HOUSTON LIGHTING & POWER COMPANY
CITY PUBLIC SERVICE BOARD OF SAN ANTONIO
CENTRAL POWER AND LIGHT COMPANY
CITY OF AUSTIN, TEXAS
DOCKET NO. 50-498
SOUTH TEXAS PROJECT, UNIT 1
AMENDMENT TO FACILITY OPERATING LICENSE

Amendment No. 36
License No. NPF-76

Amendment No. 27
License No. NPF-80

ATTACHMENT TO LICENSE AMENDMENT NOS. 36 AND 27
FACILITY OPERATING LICENSE NOS. NPF-76 AND NPF-80
DOCKET NOS. 50-498 AND 50-499

FIGURE 3.4-2

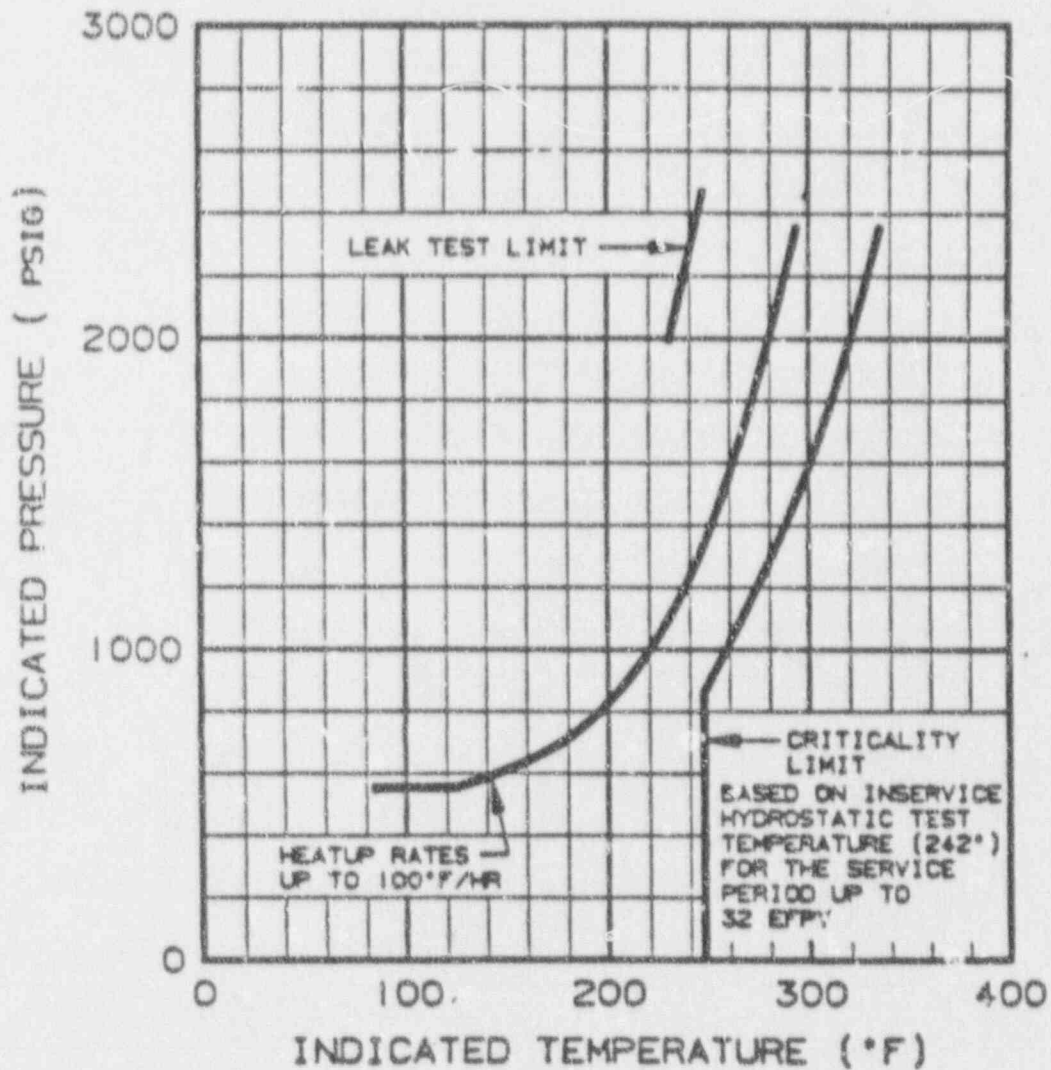
3.4.9.1 The Reactor Coolant System (except the pressurizer) temperature and pressure shall be limited in accordance with the limit lines shown on Figures 3.4-2 and 3.4-3 during heatup, cooldown, criticality, and inservice leak and hydrostatic testing with:

4.4.9.1.2 The reactor vessel material irradiation surveillance specimens shall be removed and examined, to determine changes in material properties, as required by 10 CFR Part 50, Appendix H. The results of these examinations shall be used to update Figures 3.4-2 and 3.4-3.

CONTROLLING MATERIAL - RV
INTERMEDIATE SHELL R-1606-3
COPPER CONTENT: CONSERVATIVELY
ASSUMED AS 0.10 WTX

RT_{NDT} INITIAL: 10°F
RT_{NDT} AFTER 32 EPFY
1/4, 91°F
3/4T, 64°F

CURVE APPLICABLE FOR HEATUP RATES UP TO 100°/HR FOR
THE SERVICE PERIOD UP TO 32 EPFY AND CONTAINS MARGINS OF
10°F AND 60 PSIG FOR POSSIBLE INSTRUMENT ERRORS
